Access Compliance Report

Public Rights-of-Way

(Curb Ramps)

Intersection ID: 45152	Main Street: REID_OAKS_DR	Cross Street: REID_PARK_LN	Location: SW
ADA ID: 36D8617B35C0	Ramp Type: PerpDiag	Initial Pass/Fail: Fail	Overall Compliance: No
Severity Score: 8.75			
Codes/Mitigation Info/Possible Solution		Field Measurements/Component Compliance

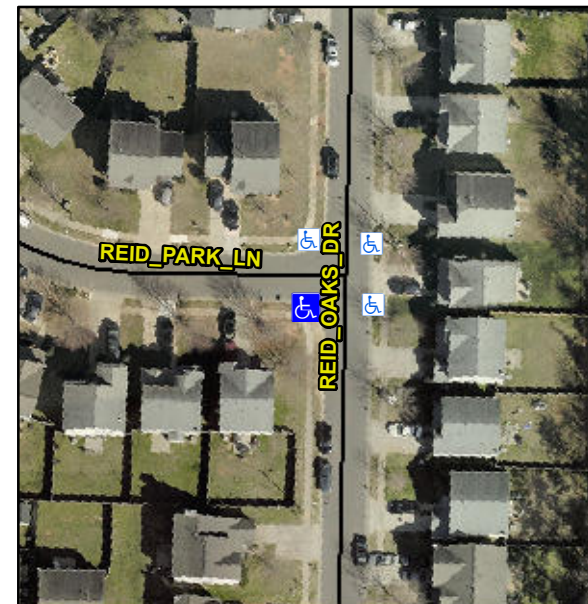
Not Found, R304.5.1

Compliance	Description	Data	Compliance	Description	Data
N/A	Ramp Length (in)	46.0	Yes	Ramp Slope (%)	5.7
No	Ramp Width (in)	47.5	Yes	Ramp XSlope (%)	1.4
N/A	Flare Type LT	N/A	N/A	Flare Type RT	N/A
N/A	Flare Slope LT (%)	N/A	N/A	Flare Slope RT (%)	N/A
N/A	Flare Traversable LT?	N/A	N/A	Flare Traversable RT?	N/A
N/A	Landing Length (in)	N/A	N/A	DWS Provided?	N/A
N/A	Landing Width (in)	N/A	N/A	DWS Contrast?	N/A
N/A	Landing Slope (%)	N/A	N/A	DWS Length (in)	N/A
N/A	Landing X Slope (%)	N/A	N/A	DWS Full Width?	N/A
N/A	Landing Curb? (Y/N)	N/A	N/A	DWS Offset (in)	N/A
N/A	Shared Landing?	N/A			
N/A	Gutter Ponding?	N/A	N/A	Gutter Slope (%)	N/A
N/A	Gutter Lip Ht (in)	N/A	N/A	Gutter X Slope (%)	N/A
N/A	Painted X Walk1?	No	N/A	Painted X Walk2?	No
	X Walk 1 Direction	To E		X Walk 2 Direction	To N
N/A	X Walk 1 Width (in)	N/A	N/A	X Walk 2 Width (in)	N/A
	X Walk 1 Slope (%)	5.4		X Walk 2 Slope (%)	2.8
	X Walk 1 X Slope (%)	0.7		X Walk 2 X Slope (%)	4.8

Remove & Replace Curb Ramp With Two New Directional Ramps or Equivalent.
